#### 49 CFR Part 571

#### Federal Motor Vehicle Safety Standards; Electric-Powered Vehicles: Electrolyte Spillage and Electrical Shock Protection

**ACTION:** Notice of proposed rulemaking (NPRM).

Figure 1. S7.6.6 Measurement of High Voltage Source for Vb Voltage

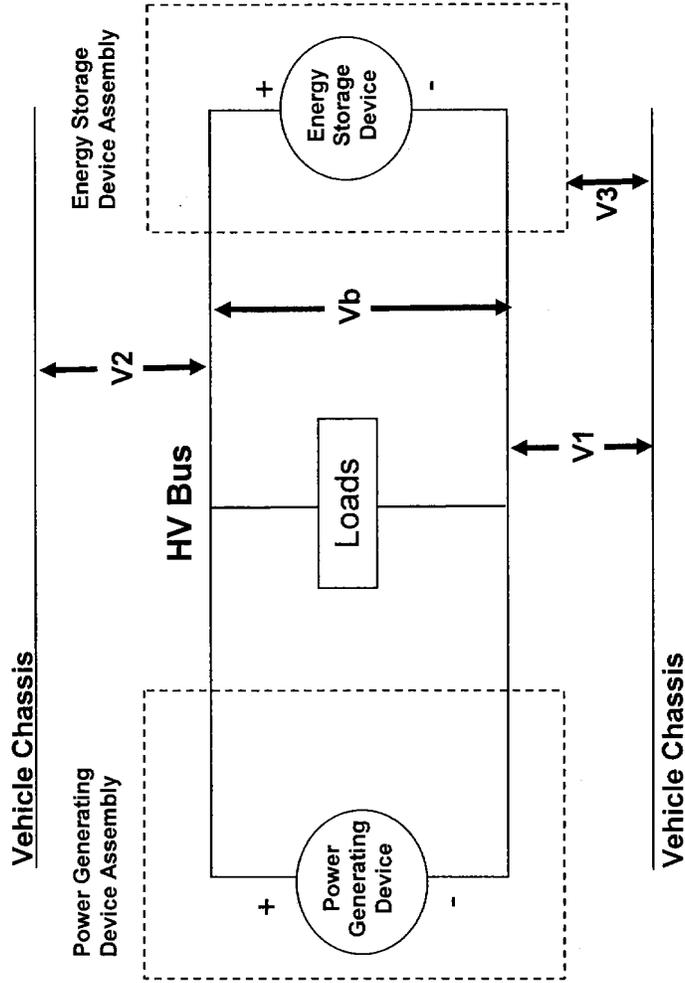
S7.6.3 The voltage(s) is/are measured as shown in Figure 1 and the high-voltage source voltage(s) (Vb) is/are recorded. Before any vehicle impact test, Vb is equal to or greater than the nominal operating voltage as specified by the vehicle manufacturer.

Figure 2. S7.6.4 Measurement for V1 Voltage between the Negative Side of the High Voltage Source and the Vehicle Chassis

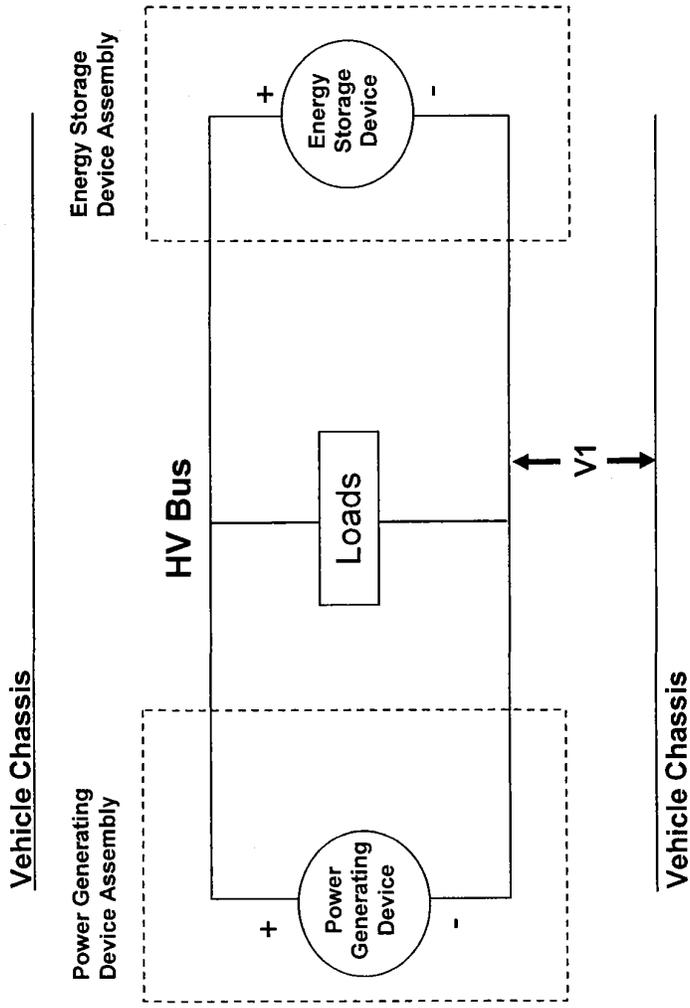
S7.6.4 The voltage(s) is/are measured as shown in Figure 2, and the voltage(s) (V1) between the negative side of the high-voltage source and the vehicle chassis is/are recorded.

Figure 3. S7.6.5 Measurement for V2 Voltage between the Positive Side of the High Voltage Source and the Vehicle Chassis

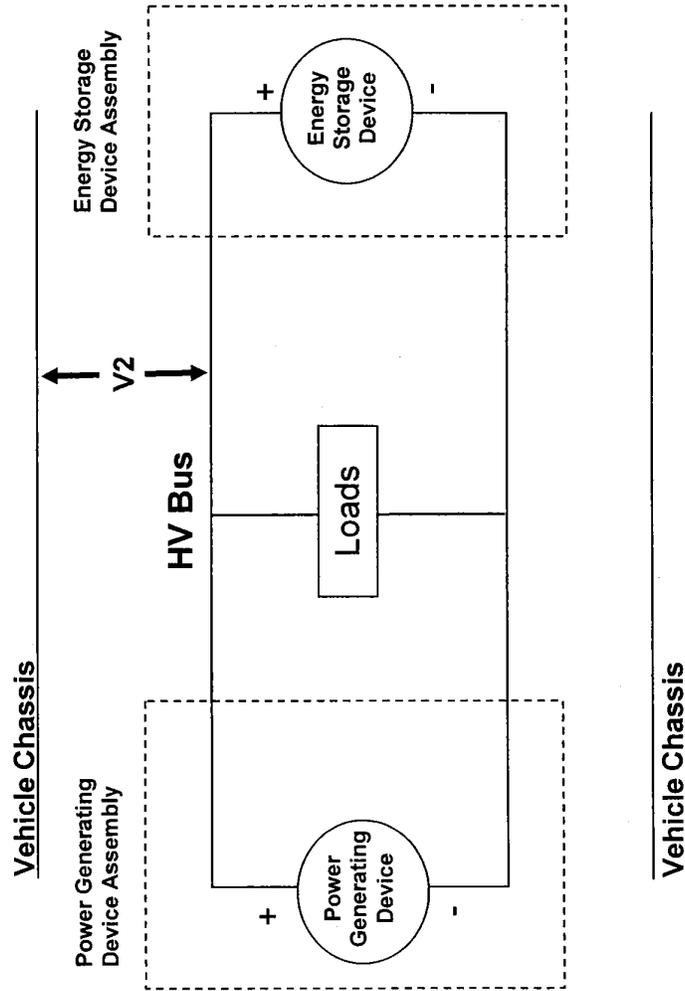
S7.6.5 The voltage(s) is/are measured as shown in Figure 3, and the voltage(s) (V2) between the positive side of the high-voltage source and the vehicle chassis is/are recorded.

Figure 4. S7.6.6 Measurement for V1' Voltage across Resistor between Negative Side of the High Voltage Source and Vehicle Chassis

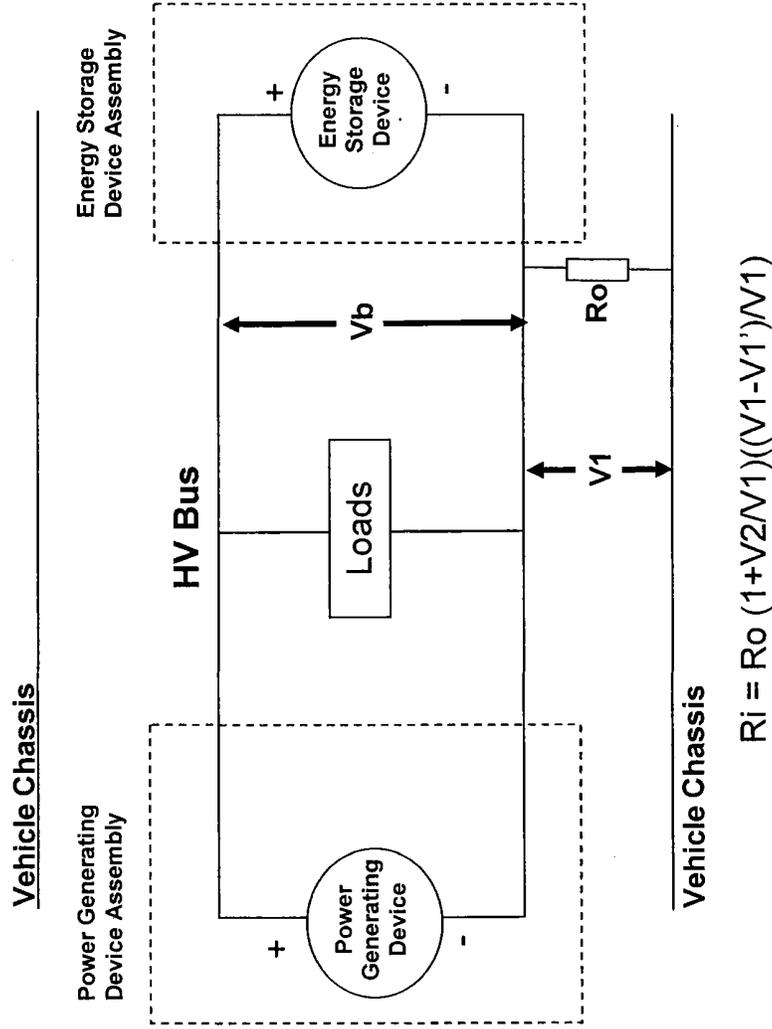
S7.6.6 If V1 is greater than or equal to V2, insert a known resistance (Ro) between the negative side of the high-voltage source and the vehicle chassis. With the Ro installed, measure the voltage (V1') as shown in Figure 4 between the negative side of the high-voltage source and the vehicle chassis. Calculate the electrical isolation (Ri) according to the formula shown.

Figure 5. S7.6.7 Measurement for V2' Voltage across Resistor between Positive Side of the High Voltage Source and Vehicle Chassis

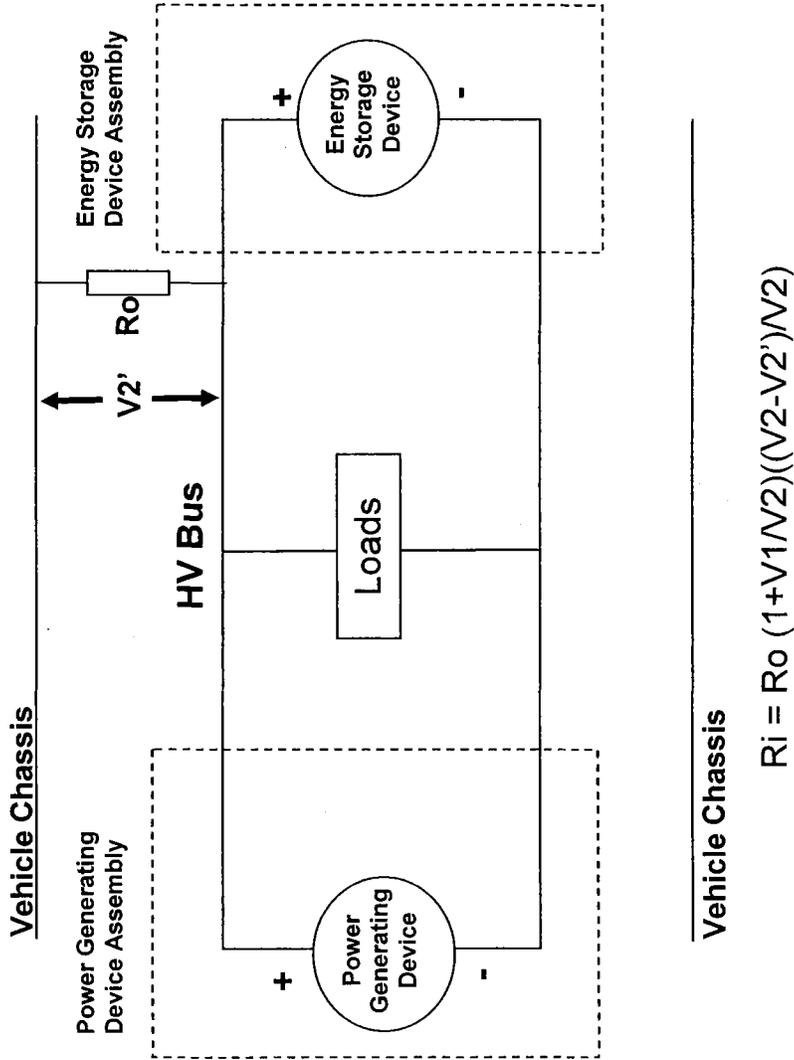
S7.6.7 If V2 is greater than V1, insert a known resistance (Ro) between the positive side of the high-voltage source and the vehicle chassis. With the Ro installed, measure the voltage and record the voltage (V2') between the positive side of the high-voltage source and the vehicle chassis as shown in Figure 5. Calculate the electrical isolation (Ri) according to the formula shown.
